TO: All Interested Bidders
SUBJECT: Invitation for Bids #16-1034CD
Wares Creek Pedestrian Bridge Replacement

ADDENDUM #1

11/18/2012-CHW12-S-102MFLDGN

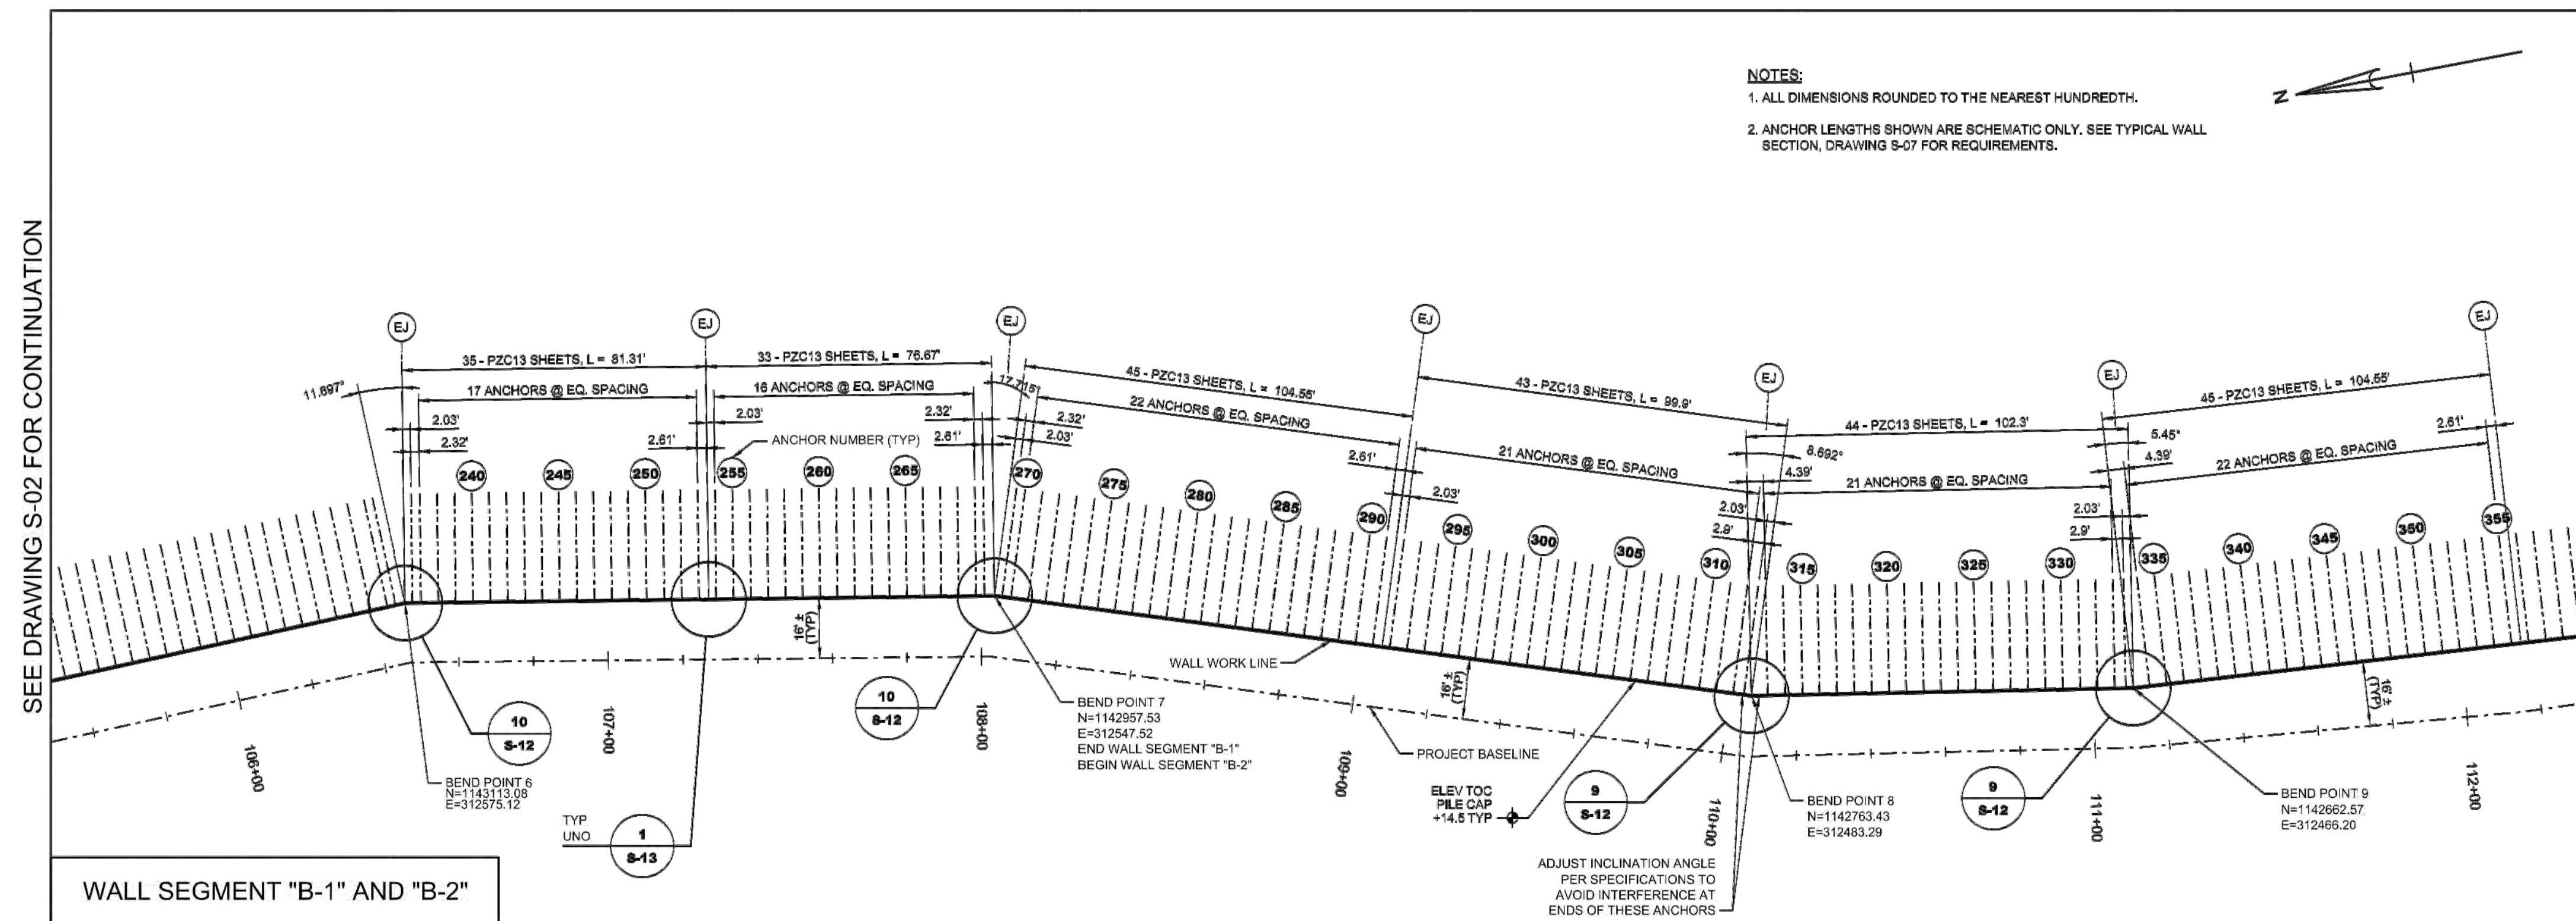
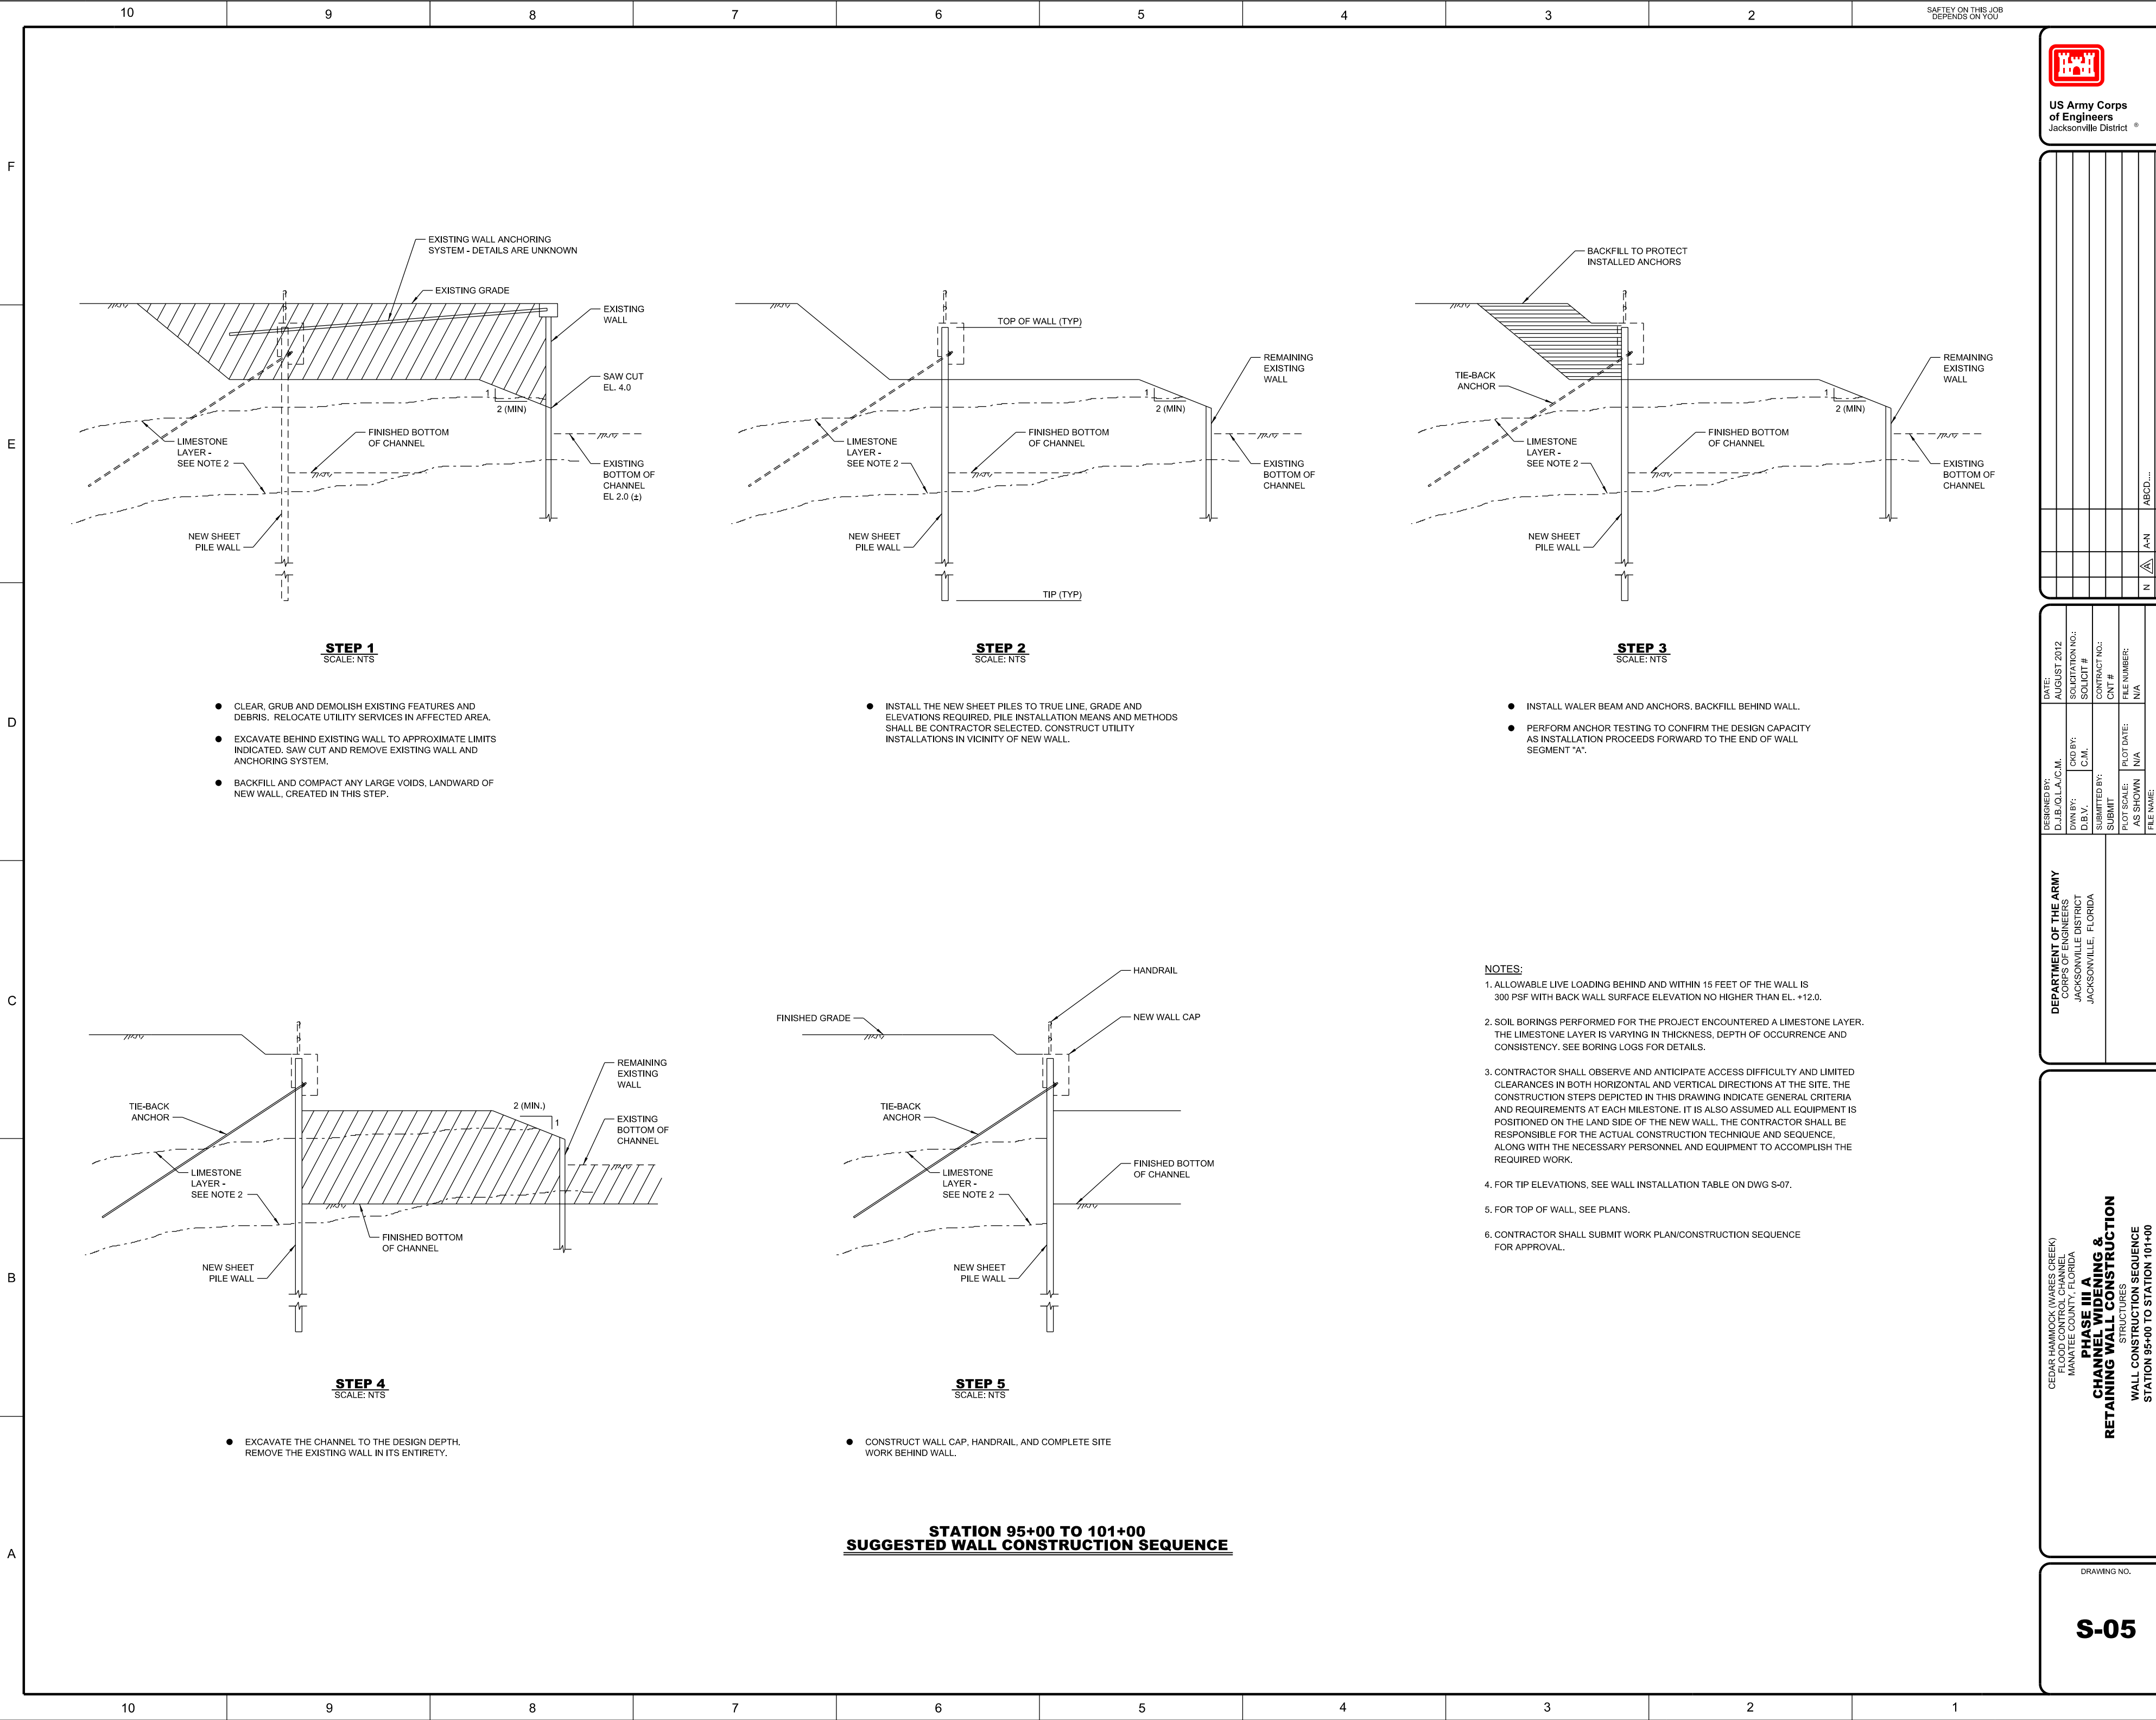
Question 9: Is there any as-built drawings for tie-backs?

Response 9: Please see attached as-built drawings for tie-back locations provided by USACE.
